# The Hub at Madison - Combined Submittal Drawings

## Supplemental Drawing Package

June 26, 2013

Please find the enclosed June 26, 2013 Supplemental Drawings which have been added to the May 22, 2013 Combined Submittal Drawings for The Hub at Madison. The Supplemental Drawings respond to feedback we have received from the Department of Planning and various neighborhood groups and committees. Included below is a list of the Supplemental Drawings with a brief description of the additions and changes included within each drawing:

**Option A - Street View from Frances Street Near Gilman Street**

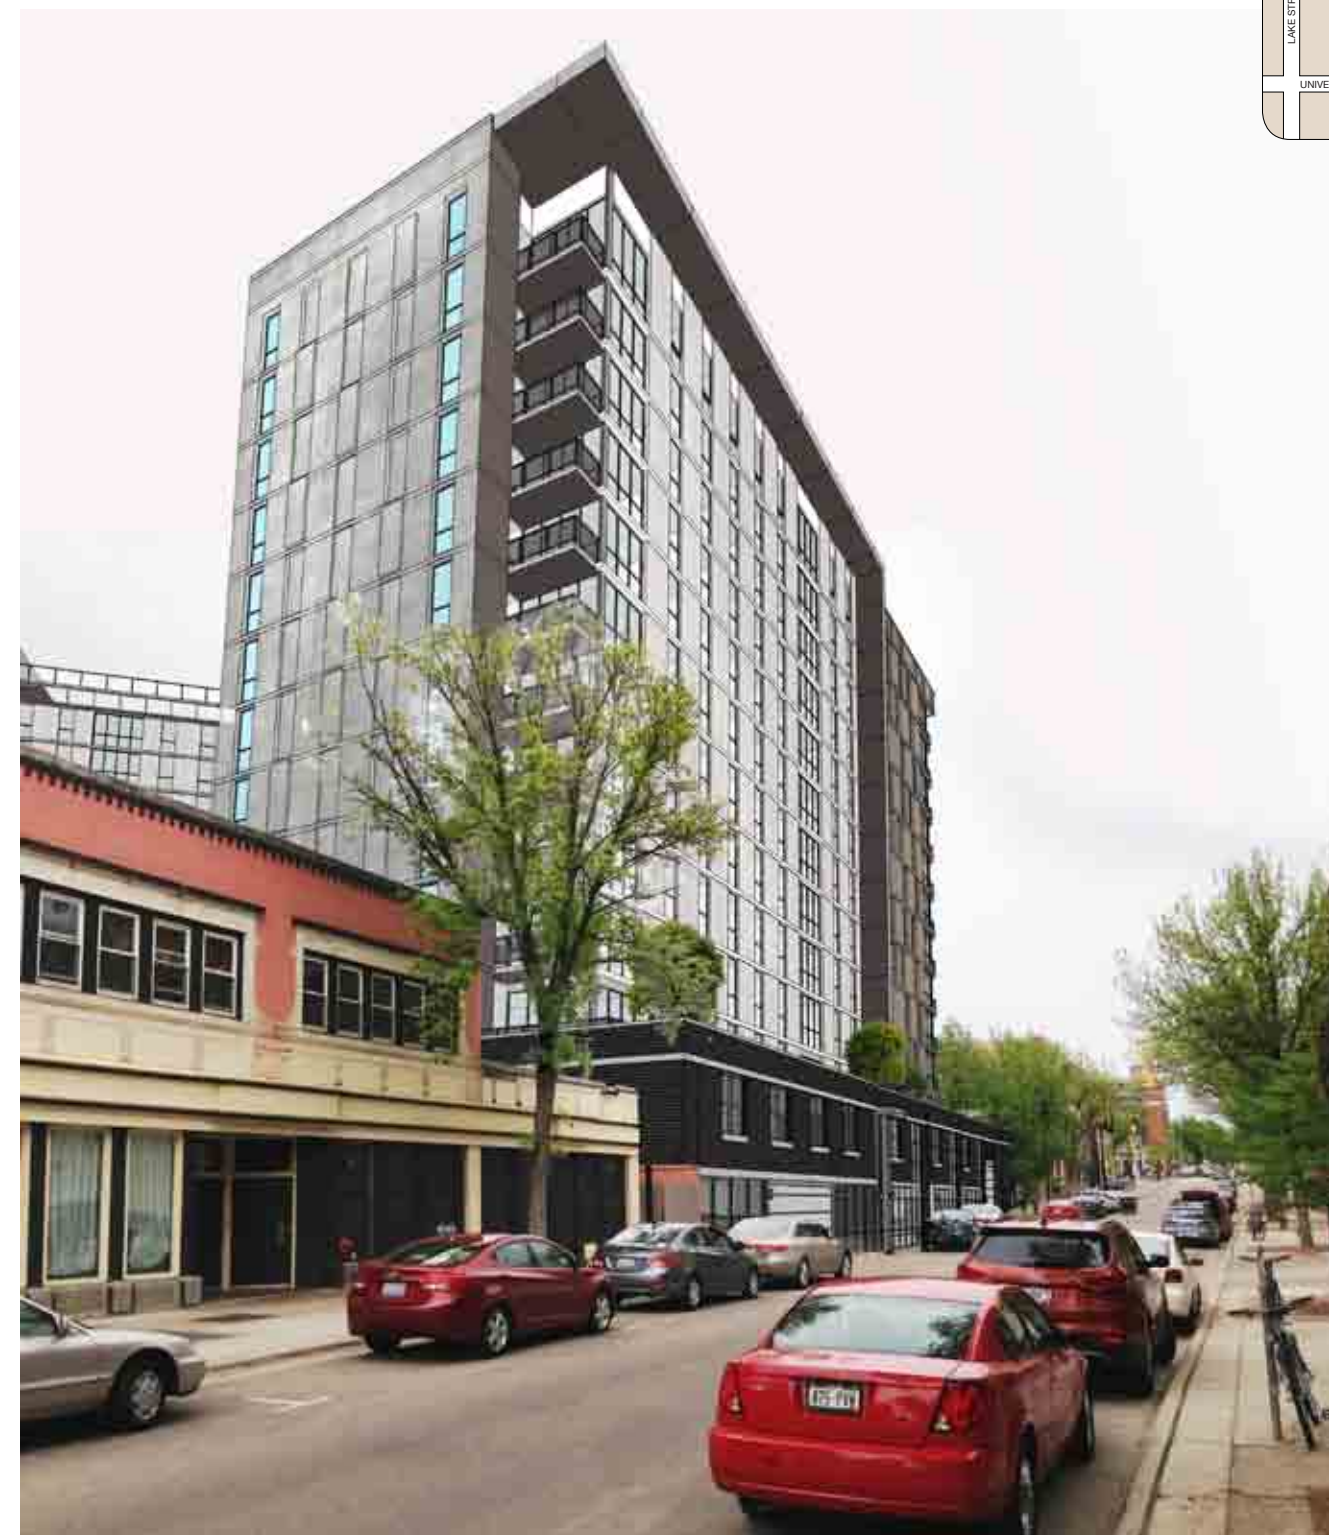
34B	View Looking Southwest on State Street - Option B / Revised shearwall design and residential window expression
34C	Enlarged View Looking Southwest on State Street / Revised retail kneewall design Operable retail windows
36A	Street View from Frances Street Near Gilman Street - Option A / Revised shearwall design

**39A**

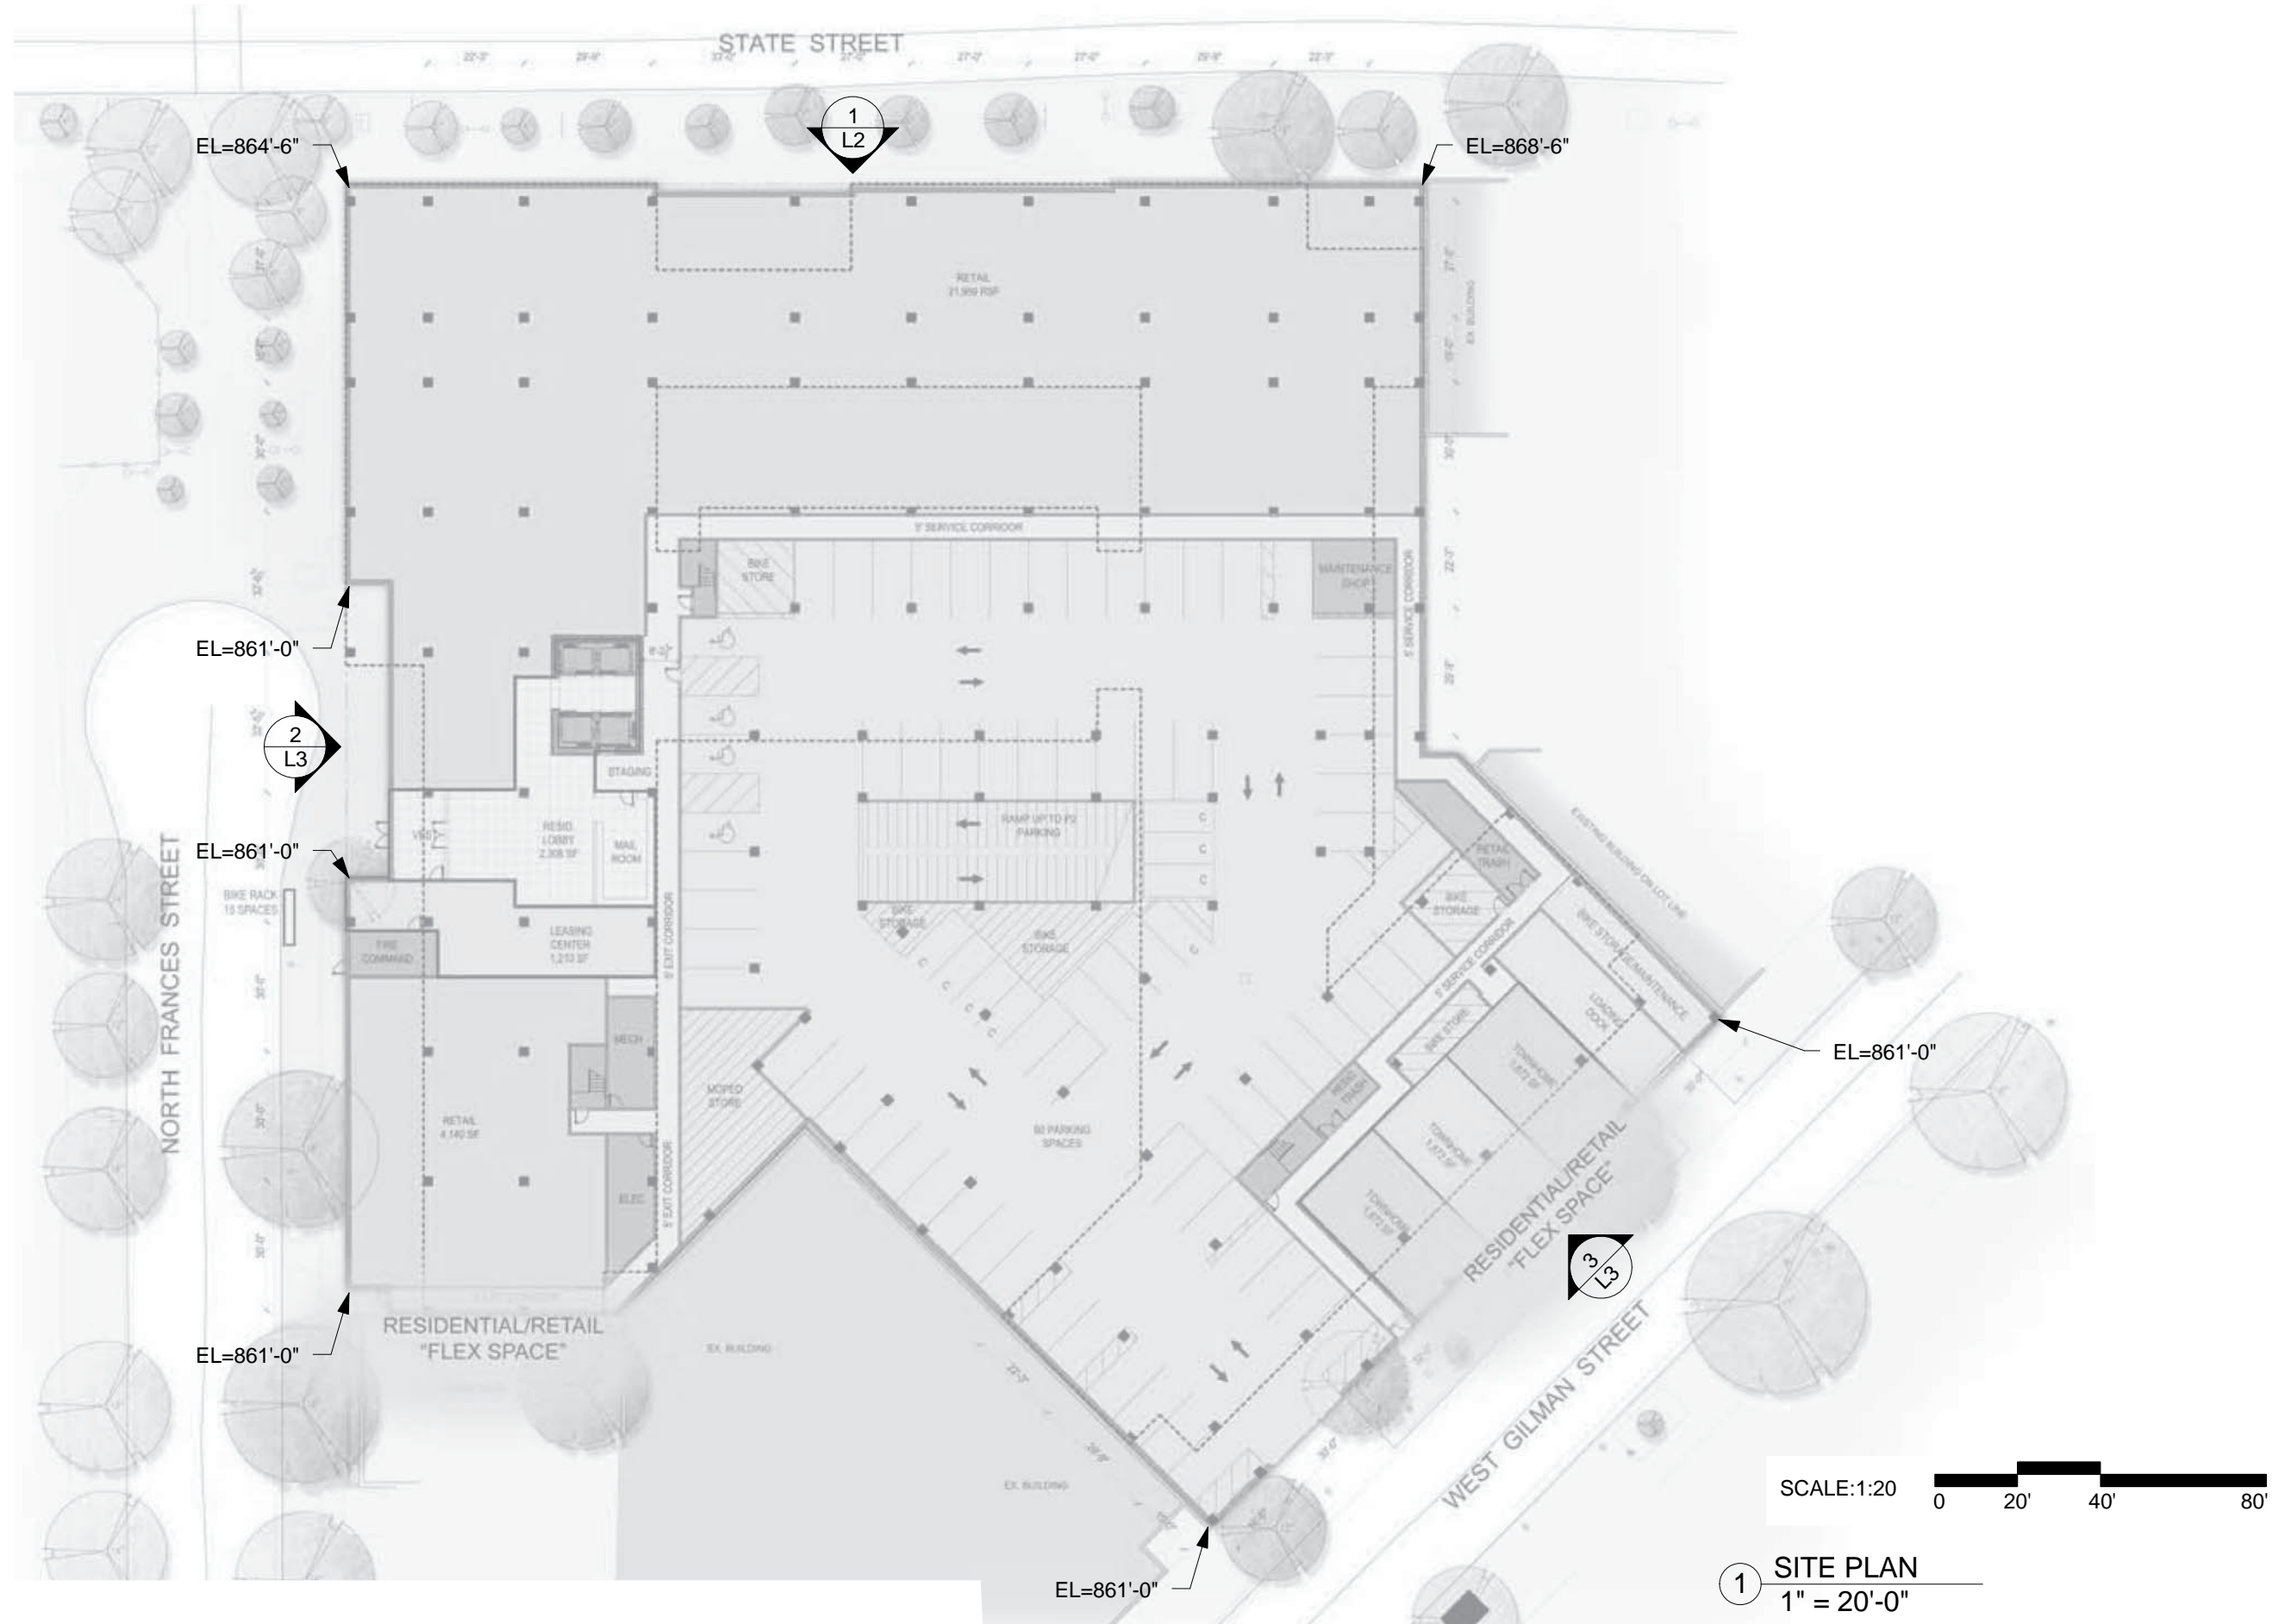
- 36B Street View from Frances Street Near Gilman Street - Option B / Revised shearwall Design and residential window expression
- 39A View Looking Northeast from Gilman Street and University Drive - Option A / Revised shearwall design
- 39B View Looking Northeast from Gilman Street and University Drive - Option B / revised shearwall design and residential window expression
- 40 Lighting Package / Key plan
- 41 Lighting Package / Building lighting at State Street
- 42 Lighting Package / Building lighting at Frances Street and Gilman Street
- 43 Lighting Package / Hub entry logo details
- 44 Lighting Package / Hub corner logo details and beacon lighting
- 45 Lighting Package / Canopy light fixtures
- 46 Lighting Package / Wall sconce fixtures
- 47 Lighting Package / Banner light fixtures
